## AGENDA MEMORANDUM

### **PL9299 Laguna Oaks Estates**

Request for a Plat Waiver of the Wastewater Infrastructure Construction Requirement  
In Sections 8.1.4.C, 8.1.5, and 8.2.7.A. of the Unified Development Code.

# Exhibit B

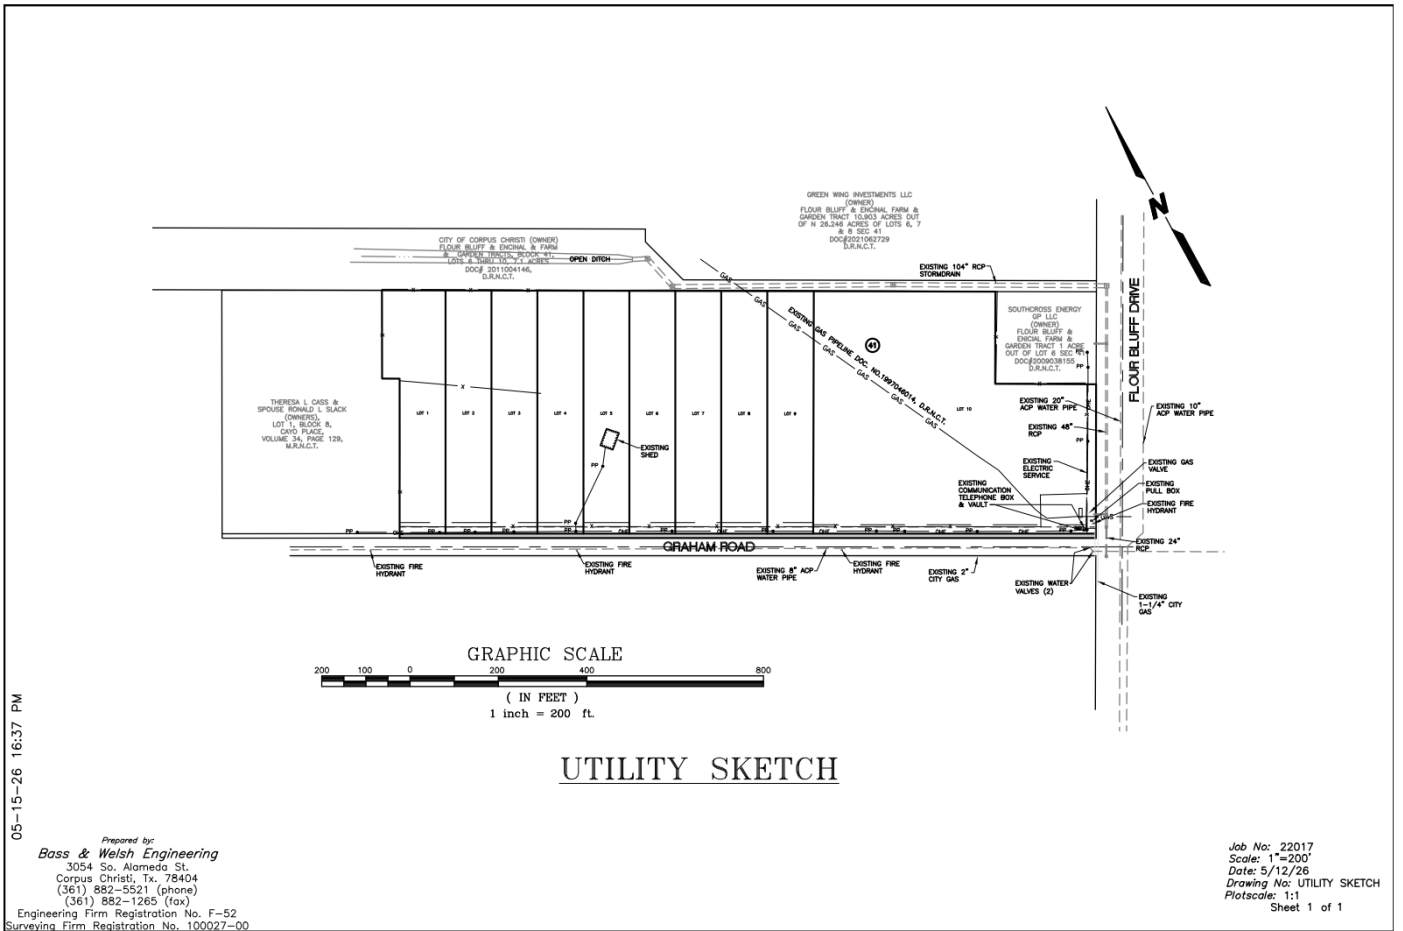
Staff conclude that the proposed Laguna Oaks Estates is “reasonably accessible” to existing public wastewater infrastructure. The closest manhole lies within roughly 1,000 linear feet although its depth is limited, it could still serve the development through a pumping system. A second manhole, approximately 1,023 linear feet away, can provide gravity service not only to this project but also to much of the remaining undeveloped frontage along Flour Bluff.

**Staff recommends denial of the request for waiver** of wastewater infrastructure construction per Section 8.2.7.A.
